GARD response to

WRSE's Consultation on their

Regional Plan for South East England

20th February 2023

Figure 1 - WRSE's assessment of future water needs

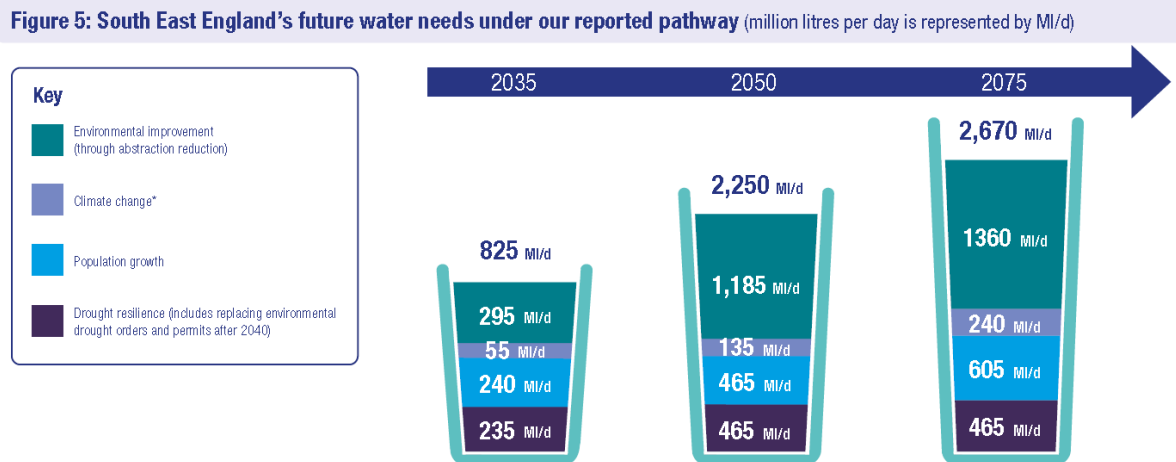
GARD’s comments on the four main sources of the needs are given in the following sections.

Figure 2 - Breakdown of drivers of investment costs in WRSE's plan

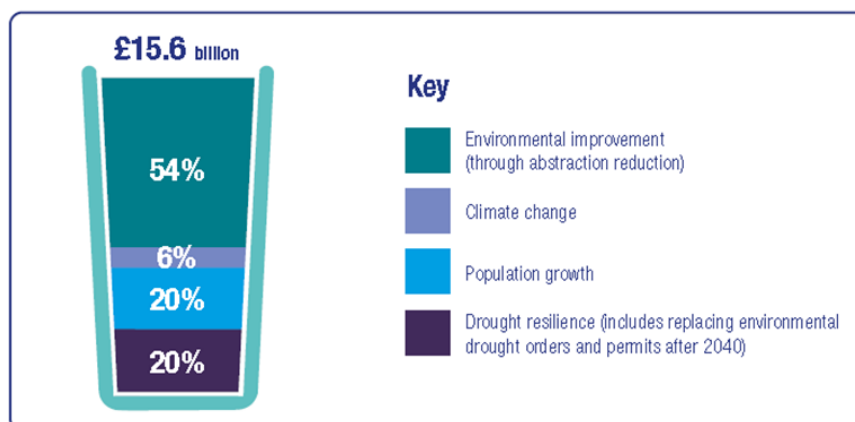
Therefore, WRSE are proposing investment of £8.4 billion in new resources to enable reduced abstraction to create environmental improvements in some rivers of the South East. In addition, the 120 Ml/d loss of deployable output through abandonment of Test and Itchen drought permits after 2040, would raise the total investment cost of environmental improvement to around £9 billion.

Figure 4 - Modelling of London DO gain from CSF proposed reductions in 1933-34

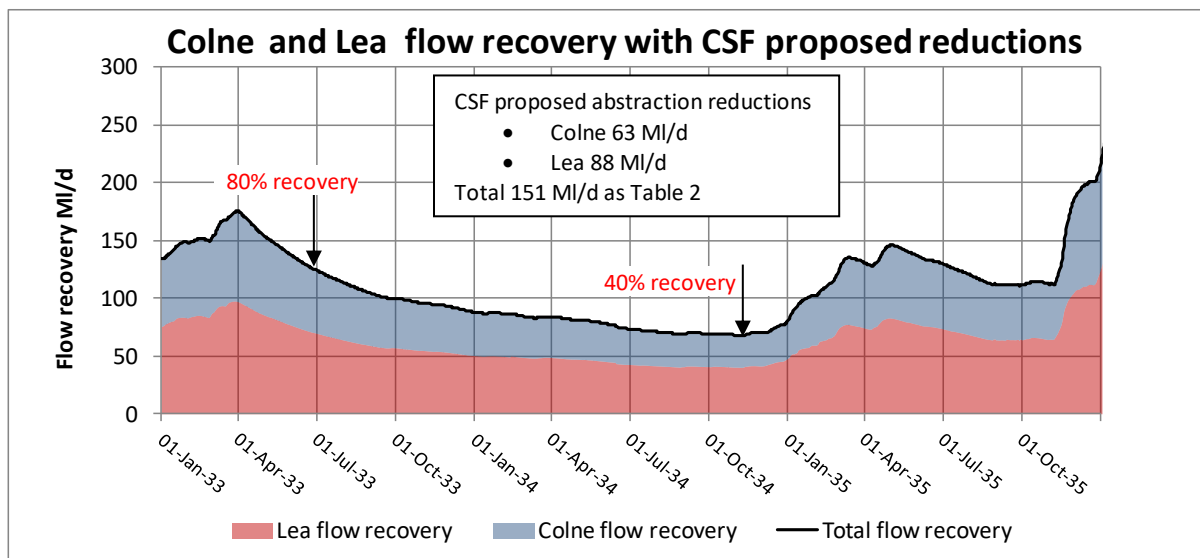
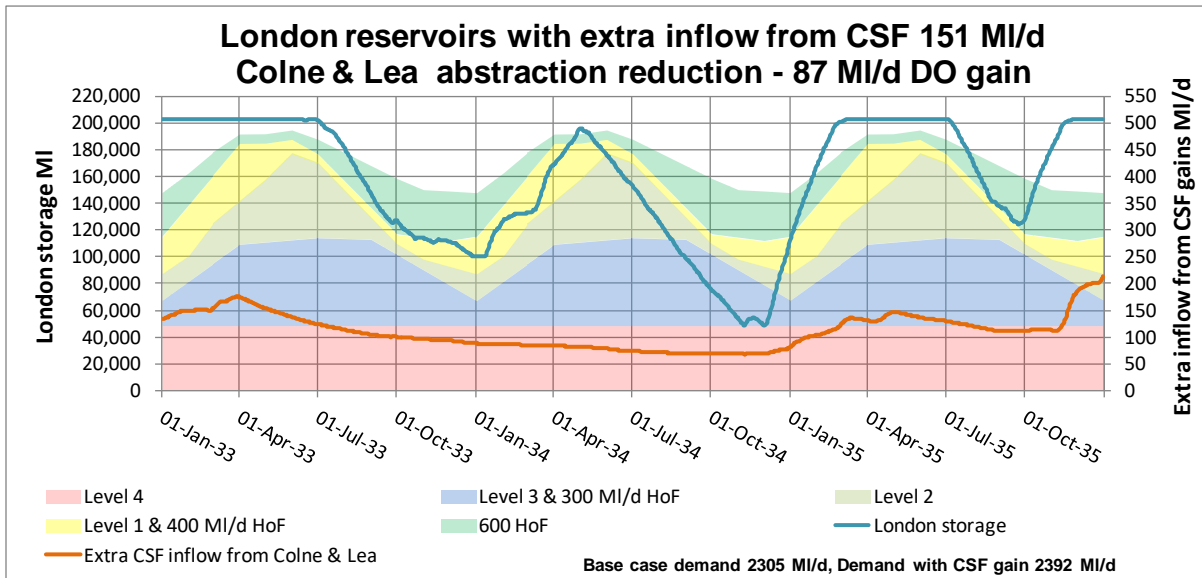
The modelled flow recovery in the 18-month drought starts at over 80% of the 151 MI/d abstraction reduction at the start of the drawdown of the London reservoirs in July 1933. The modelled flow recovery percentage drops to around 40% when London storage starts to recover in November 1933. The modelled 87 MI/d gain in deployable output is 58% of the 151 MI/d abstraction reduction – a far higher gain than the 17% assumed in current draft water company WRMPs.

It is concluded that when considering the amount of replacement sources needed for the planned abstraction reductions in the upper Colne and Lea chalk streams, the assumed deployable output recovery in the London reservoirs should be around 55-60% and not the 17% assumed in WRSE’s plan. If the deployable output recovery is, say, 55%, the 151 MI/d of gross deployable output loss from Affinity Water’s supplies would only require about 70 MI/d of replacement sources – ie 45% of 151 MI/d.

Figure 6 - Abstraction as % of Recharge for selected chalk streams

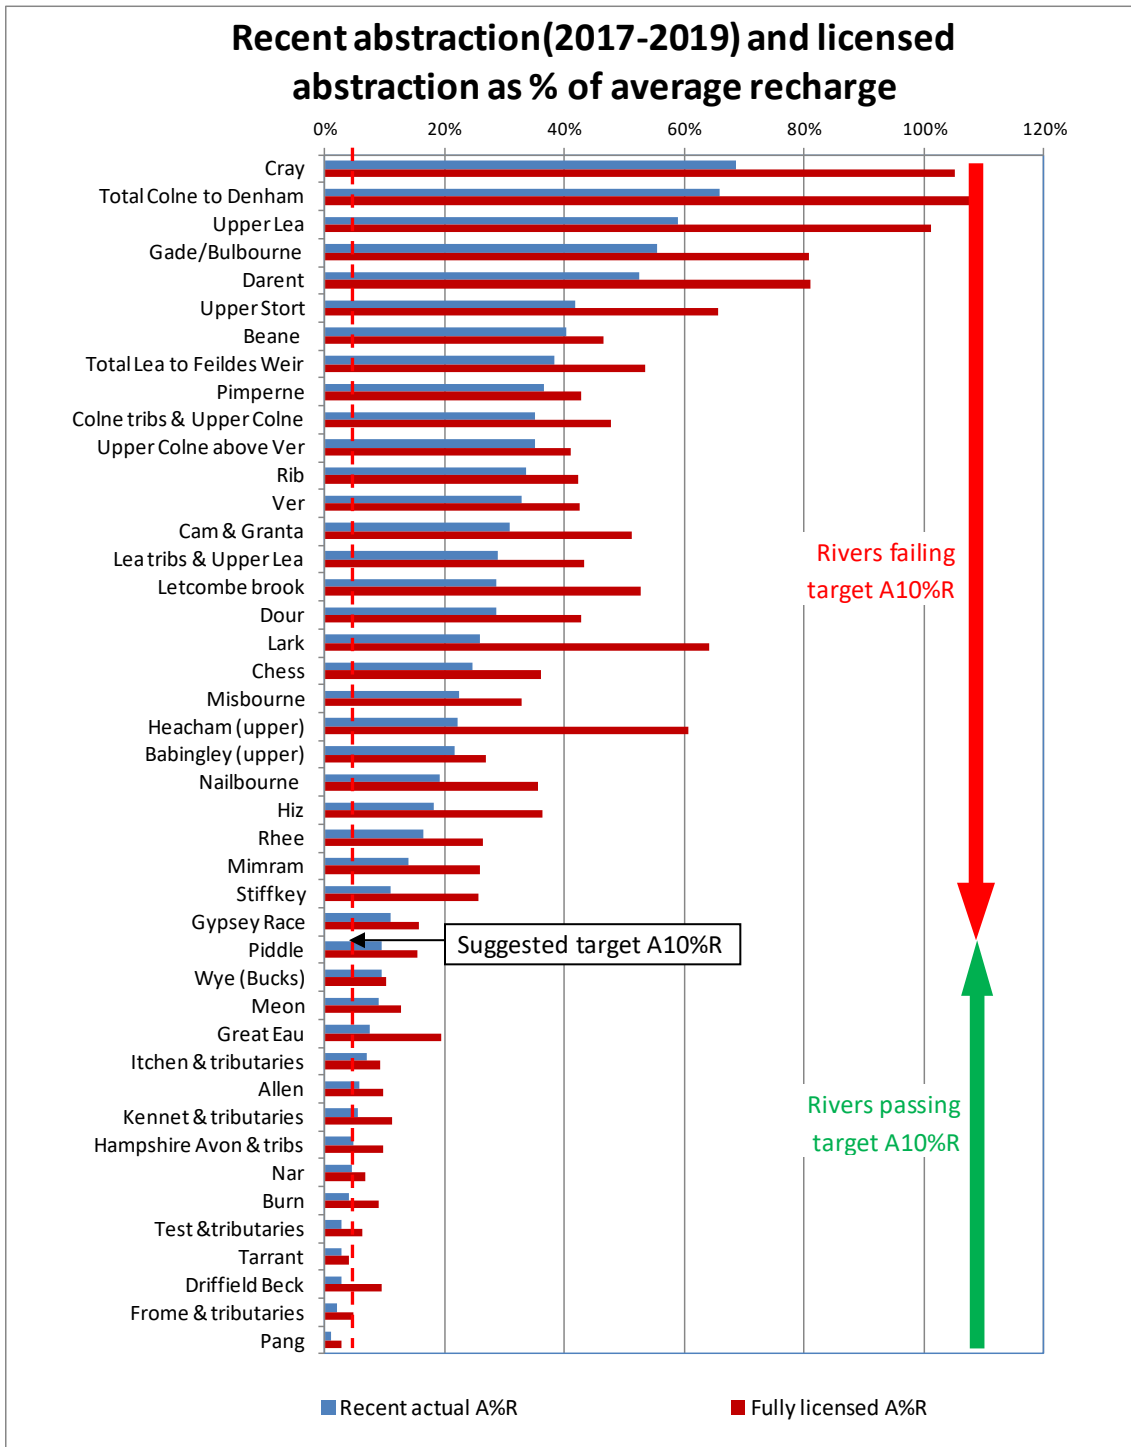
As shown on Figure 6, the A%R report identified the Darent/Cray catchment south-east of London as a major case of chalk stream over-abstraction. The A%R report suggested abstraction reduction of about 110 MI/d of reduction from recent actual amounts¹². WRSE's data in file '*GARD-09 Additional Source Level Environmental Ambition Data.xlsx*' shows a planned deployable output loss of 105 MI/d for the Darent/Cray abstraction reductions. GARD agrees with this assessment and recognises that a connection to Thames Water's London supply system is likely to be the only realistic means of enabling an abstraction reduction of this scale.

Figure 7 - Allowances for environmental improvements in other regions

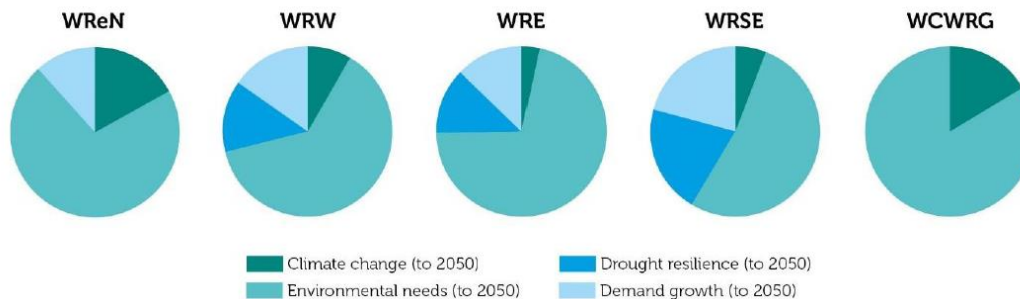
GARD has not looked into the detail of environmental ambitions for regions outside the South East, but it seems likely that they would be subject to the same criticisms as those in WRSE’s plan – excessive reductions arising from the Environment Agency’s ‘handle-turning’ methodology and gross excess of cost over benefit due to disproportionate costs of supposed compliance with the Water Framework Directive.

The significance of the large abstraction reductions outside the South East is that they limit the water available for transfer into the South East and drive up the cost of the replacement sources in transfer donor regions. Replacement source costs in the donor regions will be higher if less costly new sources are used to replace supplies lost from abstraction reductions – see later comments on selection of Abingdon reservoir ahead of the Severn to Thames transfer.

In view of the dominance of environmental improvements in the resource needs of every region, as shown in Figure 6, no decisions should be taken on the need and choice of new resource schemes until the proper and transparent prioritisation of abstraction reductions has been completed.

Figure 8 - Thames Water assumed deployable output loss due to climate change

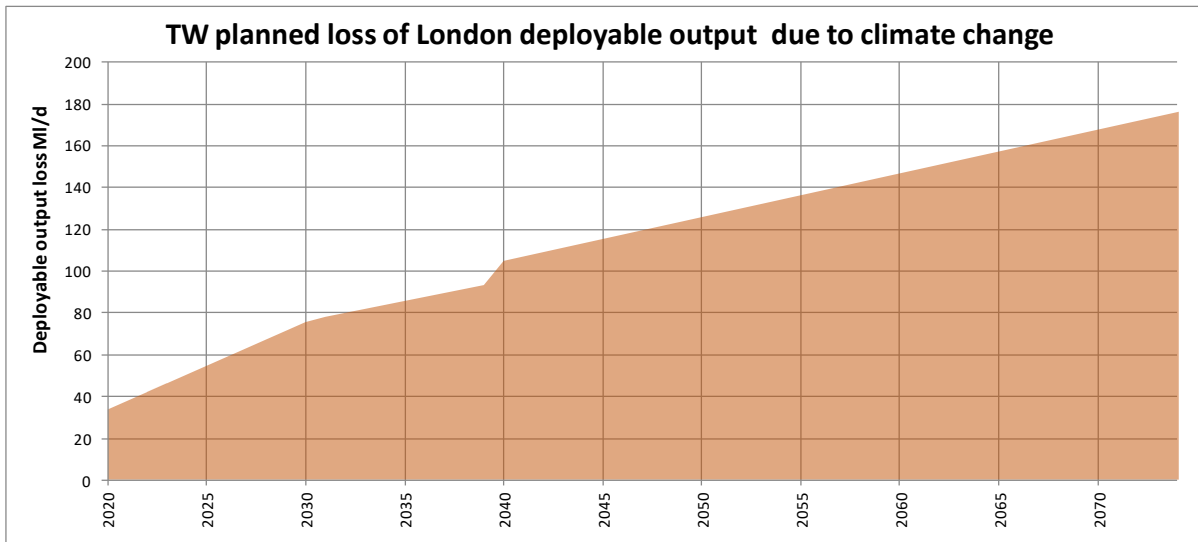
Elsewhere, supplies are largely from groundwater from which deployable outputs are not expected to be significantly affected by climate change.

Figure 10 - Comparison of Thames Water and United Utilities planned urban PCC reductions

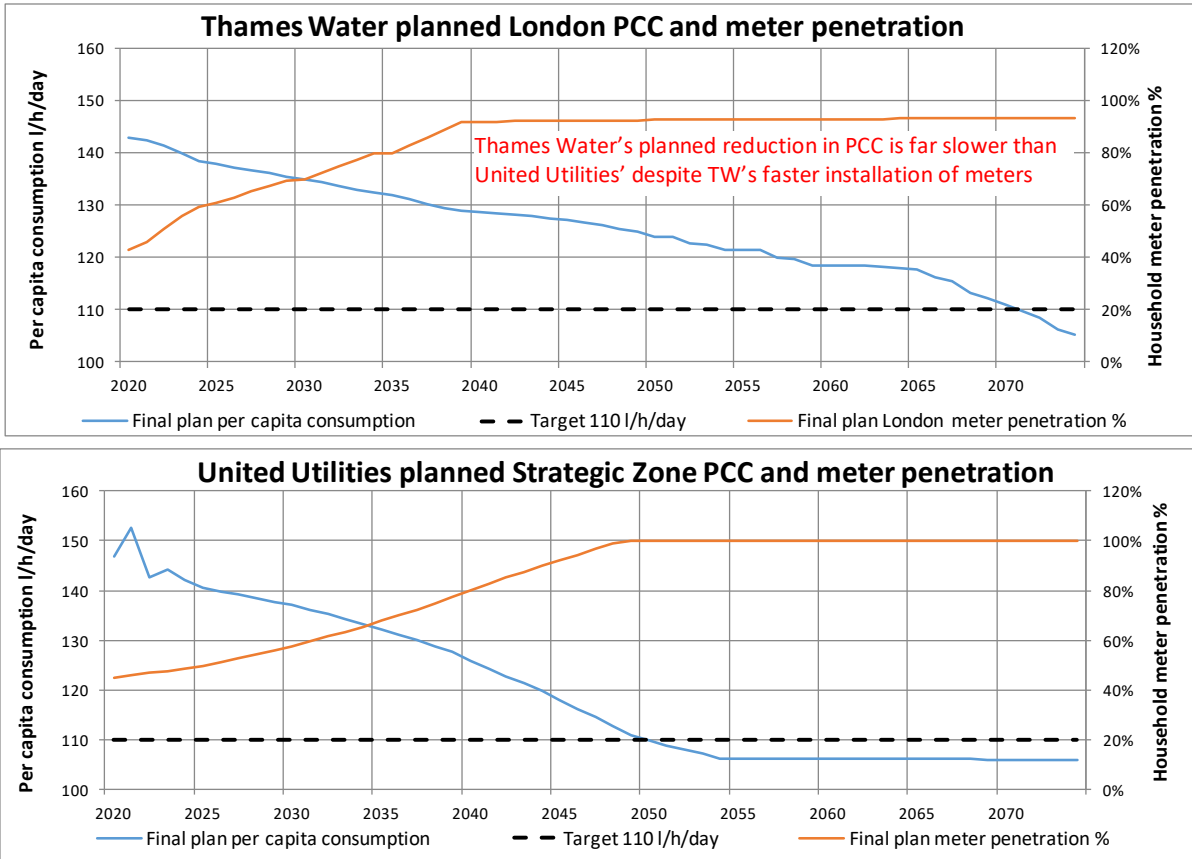
Figure 9 shows a large disparity in the planned achievement of the 110 l/person/day target despite the similarity of the zones in terms of size and urbanisation. United Utilities plan to meet the target by 2050, whereas Thames Water’s London PCC is still at 124 l/person/day in 2050 despite planned meter penetration of 90% by 2040.

Figure 11 - Thames Water leakage reductions in zones

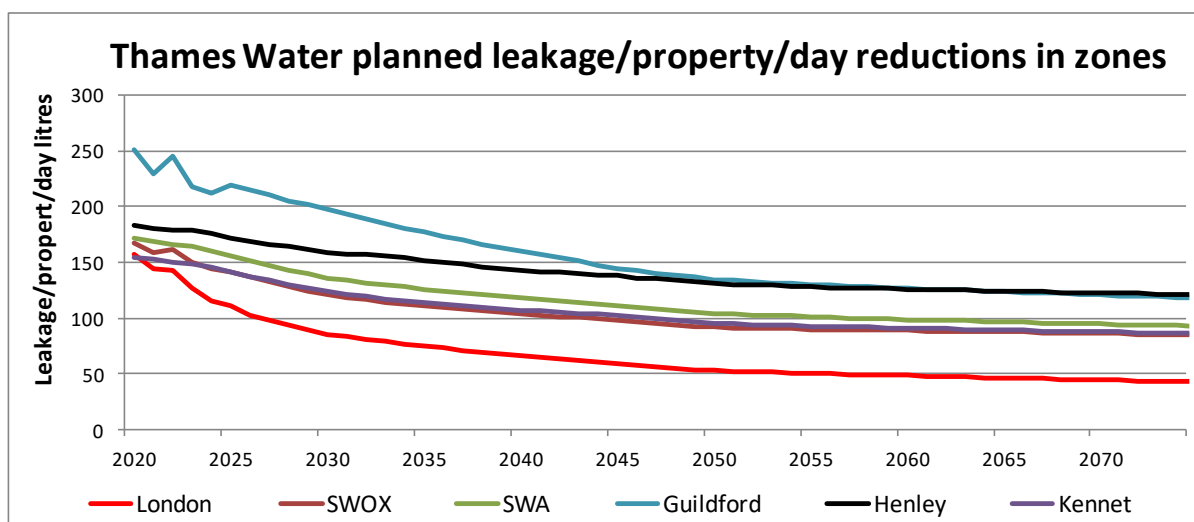
This shows that most of the planned leakage reductions are in London, where the planned gross leakage reduction is from 566 MI/d in 2017-18 to 225 MI/d in 2050, a reduction of 60% and well ahead of the Government’s 50% reduction target. GARD welcomes this and notes that the planned leakage of 53 l/property/day in 2050 is slightly less than United Utilities’ planned 56 l/property/day in their similarly urban Strategic Zone.

Figure 12 - Abingdon reservoir capital carbon hotspots

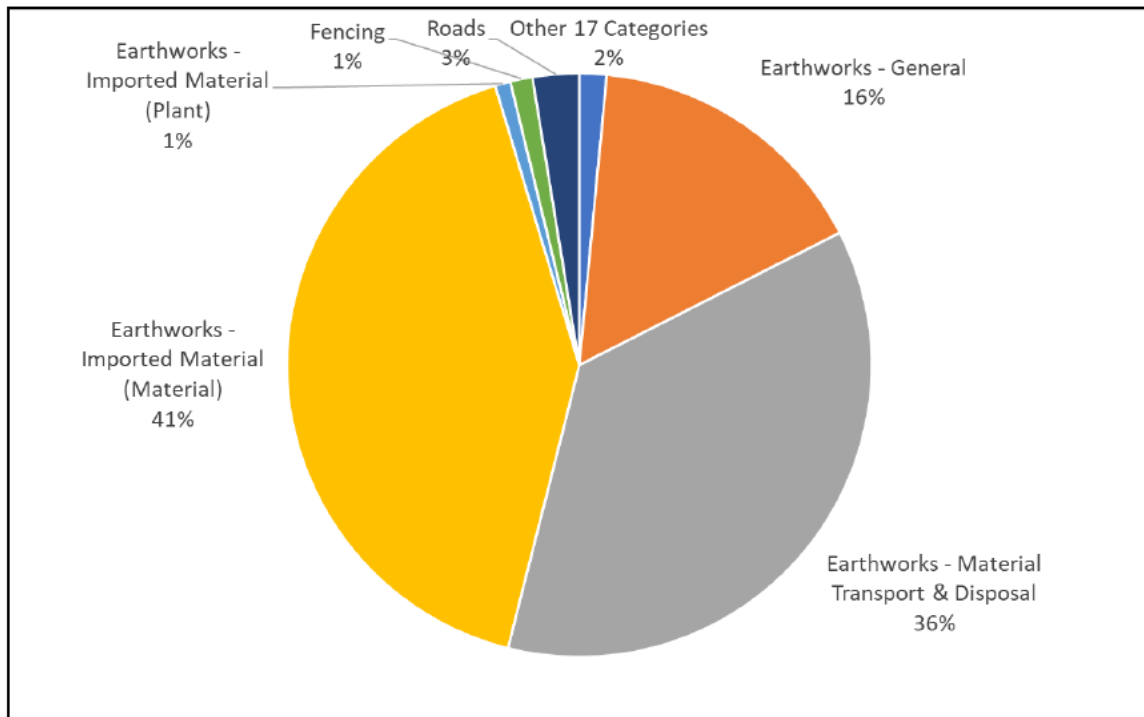
The dominant sources are 41% from quarrying and 36% from to-site transport of materials and 16% from the movement of earthworks on-site. The report purports to analyse how the embodied carbon might be reduced in the project, but the ‘analysis’ is woefully lacking in substance and hopelessly optimistic. It is also uneven in quality and philosophy when compared to that carried out for the pipe material and cement cases above. There are thus no details of technology existing, or industry-accepted roadmaps, or TRL discussion, or indeed of anything that could not be found from a Google search. Instead, anecdotal discussions are cited with two manufacturers “...indicate that prototype [hydrogen powered] large excavators (21T and 35T) and dozers are being developed and **potentially available** in the next 2 years” (ie. the *prototype* might be available). Such ‘analyses’ are used to derive an astounding (for its *chutzpah*) conclusion that a ‘mid-case’ scenario (the one taken by WRSE) could result in a 60% reduction in embodied carbon in the 2025-2040 timeframe. This analysis excludes an analysis of transport by rail (currently diesel along the Great Western Line identified for bringing the 5+ megatonnes of Rip-rap to the site), as it only mentions HGVs in the text. It depends on the availability of Hydrogenated Vegetable Oil (HVO) fuelled vehicles, to provide 50% of the fleet, in spite of the fact of admitting that:
